ADDENDUM #1

September 23, 2024
Wilson Fire Station Roof Replacement
50 Pine Lane, Windsor, CT 06095

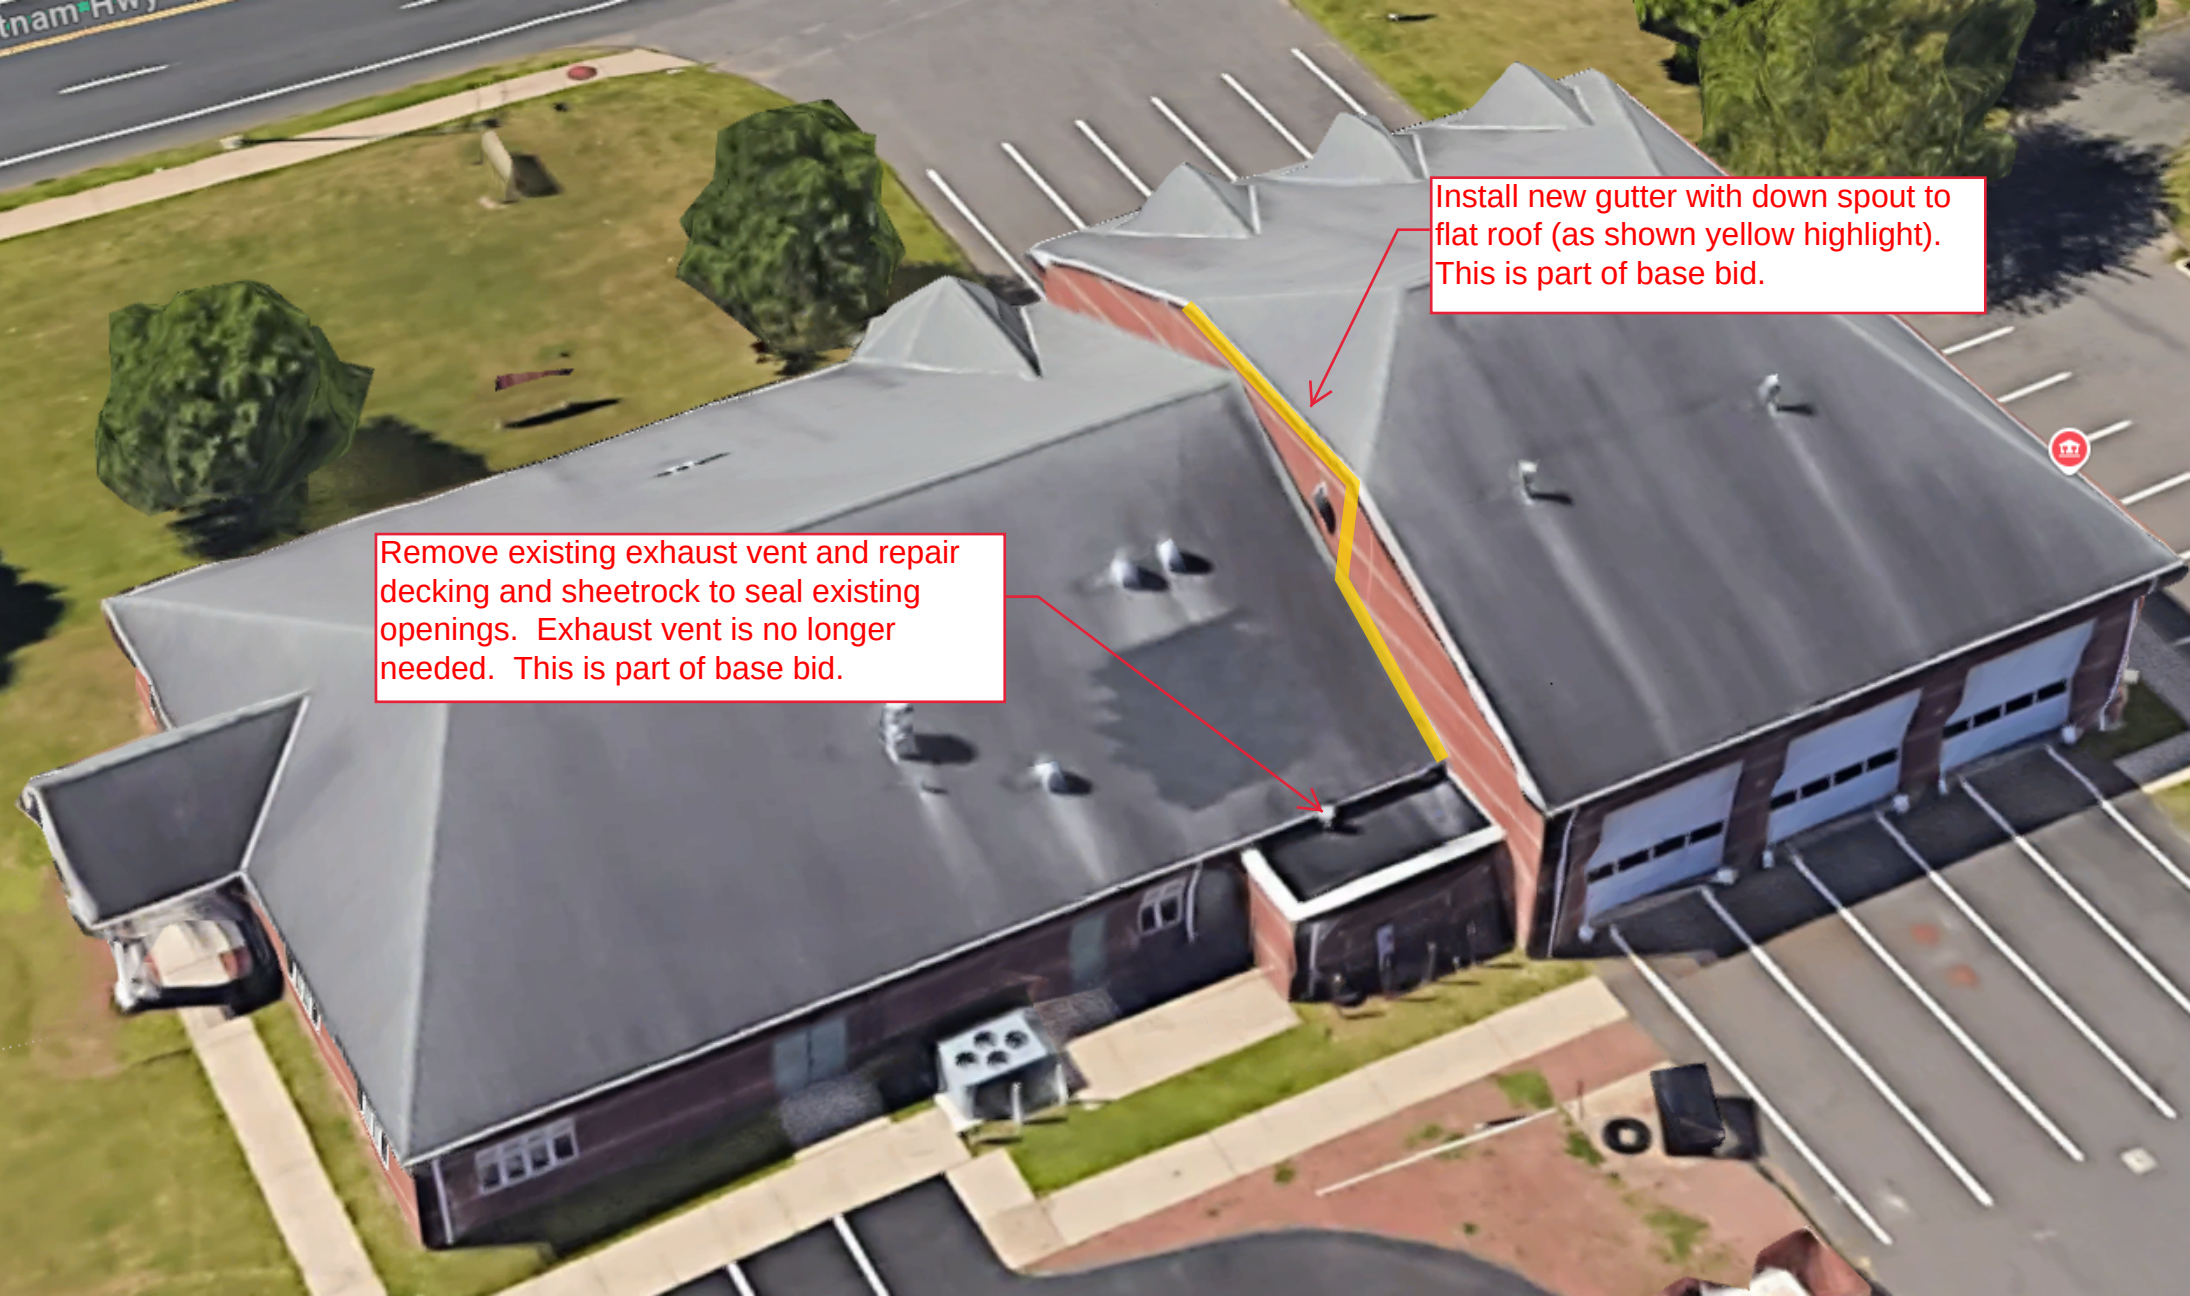
4. Seal all masonry above the roof line between the Garage and Office area with two coats of approved masonry damp proofing.
5. Add the installation of new 6K gutter to Garage roof eve above the gable between the hips, pitch it to the back of the building, pipe it down to the shingled roof, add extension to the flat low slope roof (as shown on attached drawings).

6. Install closed valleys at all valley areas.
7. Remove abandoned exhaust duct in mechanical room (flat roof area as shown on attached drawings). Repair decking and sheetrock below decking to seal penetrations from said exhaust duct.

Install new gutter with down spout to flat roof (as shown yellow highlight). This is part of base bid.

Remove existing exhaust vent and repair decking and sheetrock to seal existing openings. Exhaust vent is no longer needed. This is part of base bid.
